Through discussions with the U.S. Nuclear Regulatory Commission and the U.S. Army and at the direction of the U.S. Army, Science Applications International Corporation (SAIC) is proposing the following changes to *Field Sampling Plan (FSP) Addendum 7 – Depleted Uranium Impact Area Site Characterization: Soil Sampling and Analysis, Corrosion Study, Partition Coefficient Study, Modeling Overview, and Slug Testing*:

## **FIELD SAMPLING PLAN ADDENDUM 7**

**Depleted Uranium Impact Area Site Characterization:  
Soil Sampling and Analysis, Corrosion Study, Partition  
Coefficient Study, Modeling Overview, and Slug Testing  
Jefferson Proving Ground, Madison, Indiana**

**REVISED FINAL**

Figure 3-1. Working Conceptual Site Model of DU Transport Through the Environment at and in Close Proximity to the JPG DU Impact Area

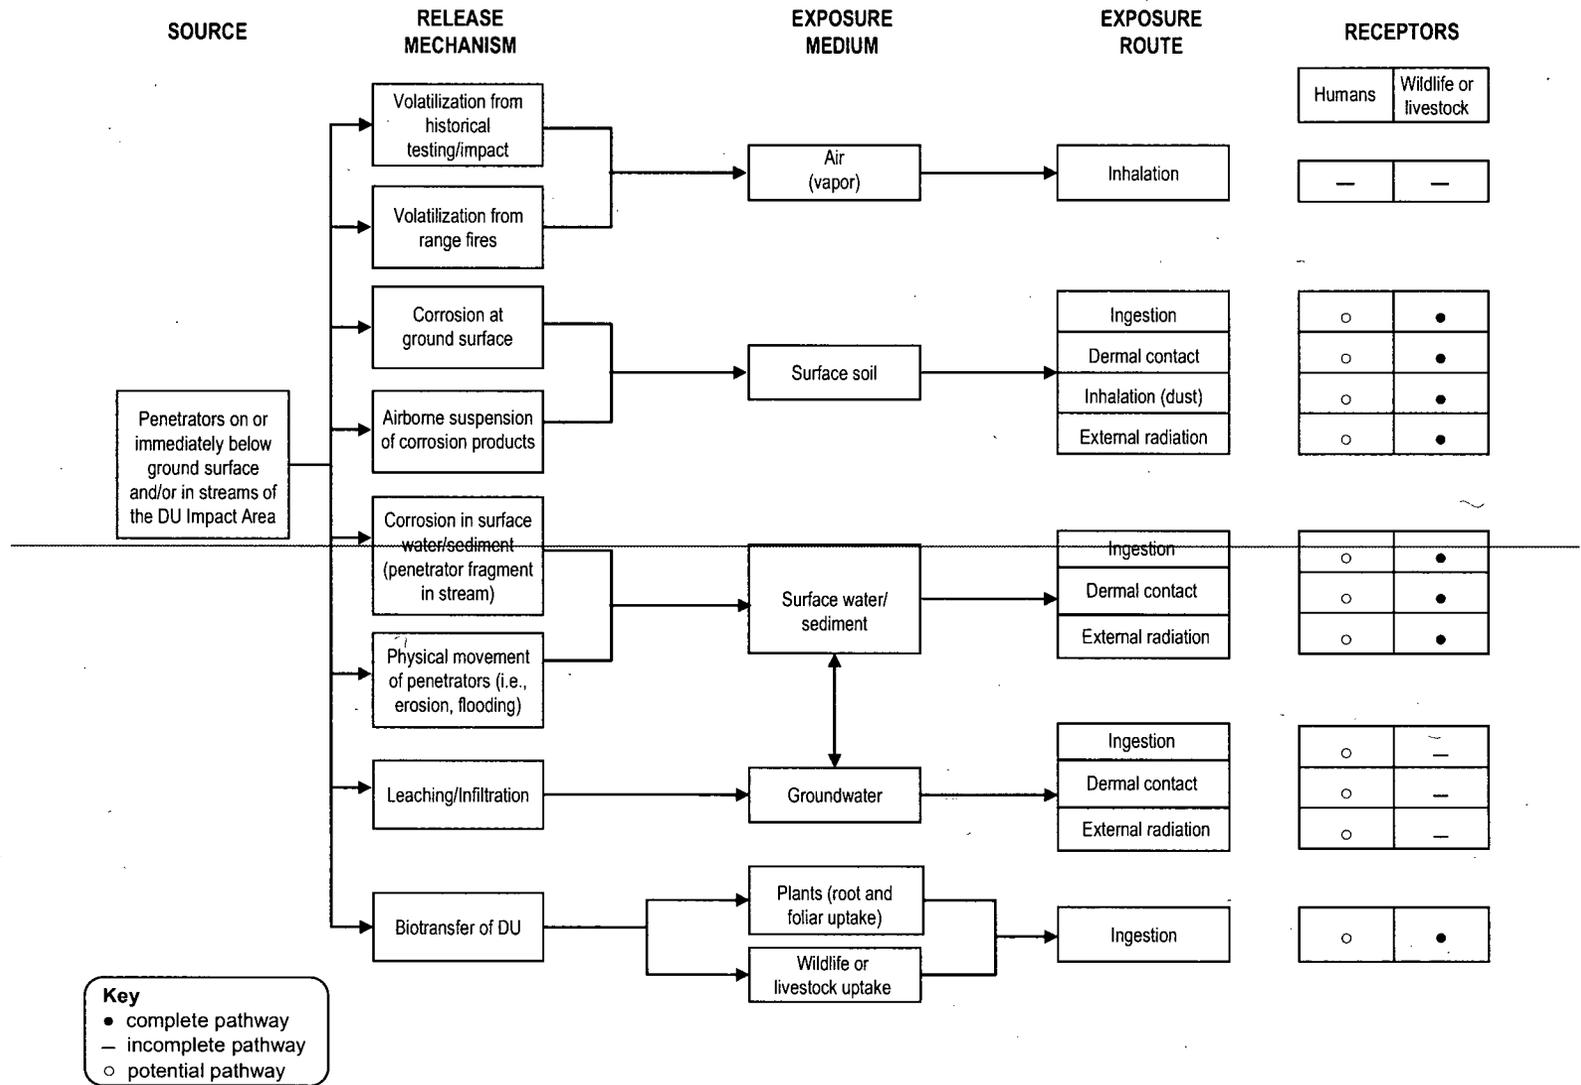
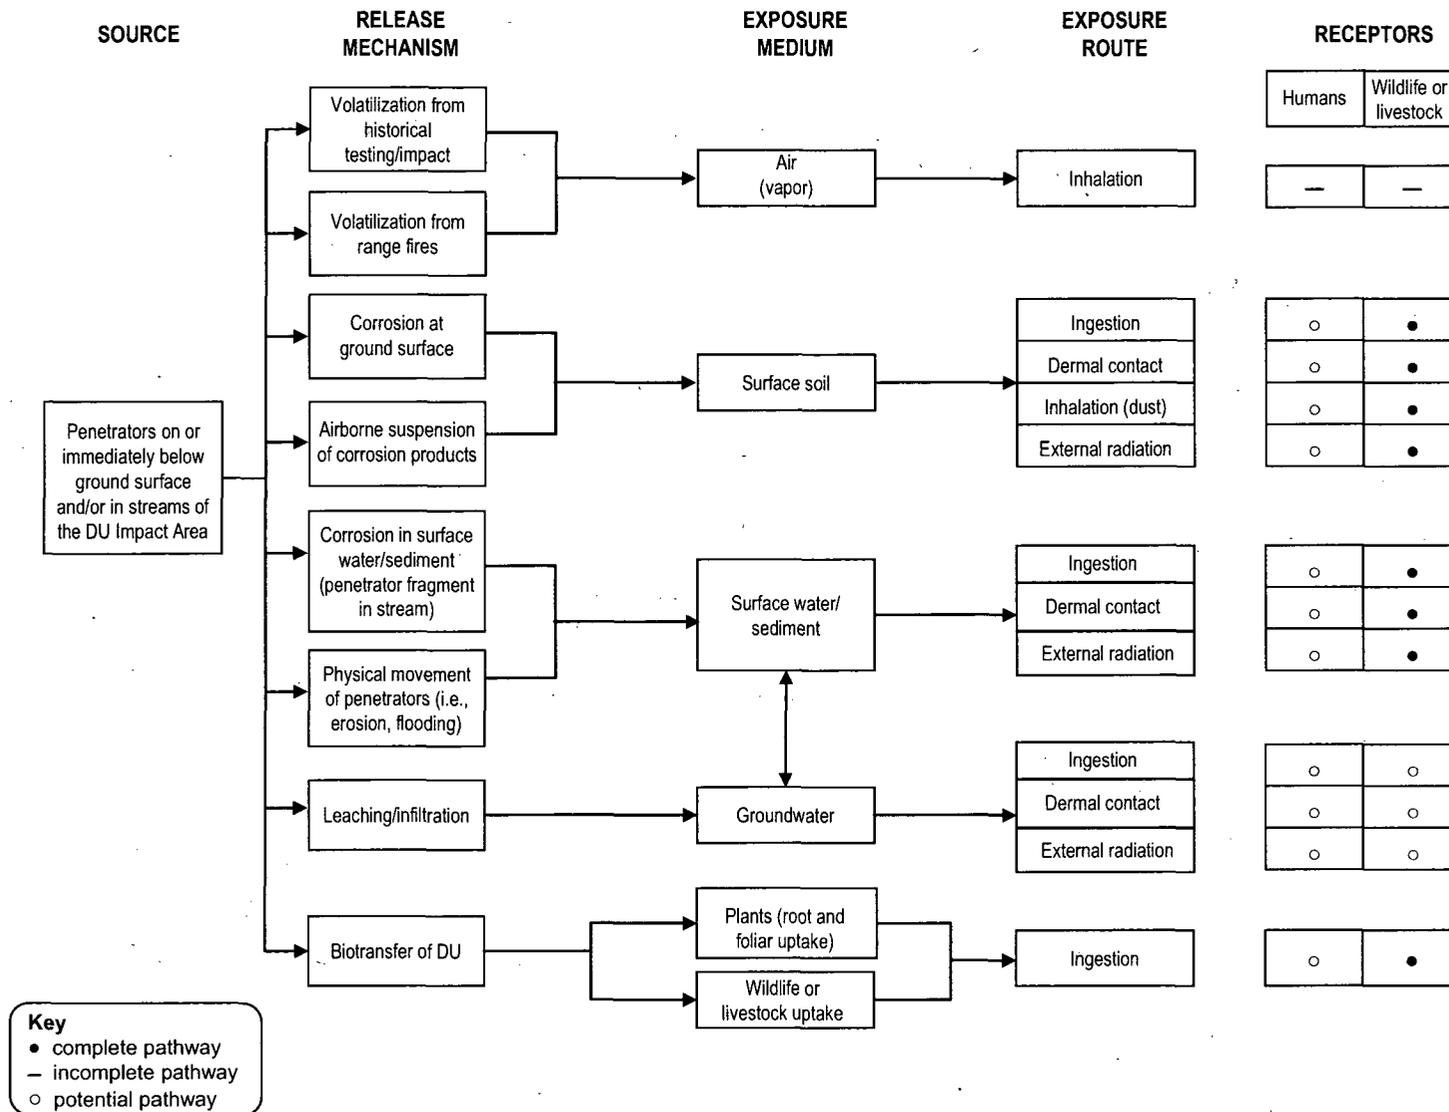
1. Change version throughout document from “Final” to “Revised Final” and date from “August 2008” to “October 2008.”
2. Change the conceptual site model (CSM, Figure 3-1) to show a pathway for wildlife or livestock receptors potentially exposed to groundwater leaching/infiltrating through soil into surface water bodies.

Figure 3-1 is a working graphical representation of the conceptual site model (CSM), including DU sources, release mechanisms, exposure mediums, potential exposure pathways, and potential receptors at JPG. This working draft of the CSM will be revised as data are collected and evaluated throughout the 5-year site characterization program.
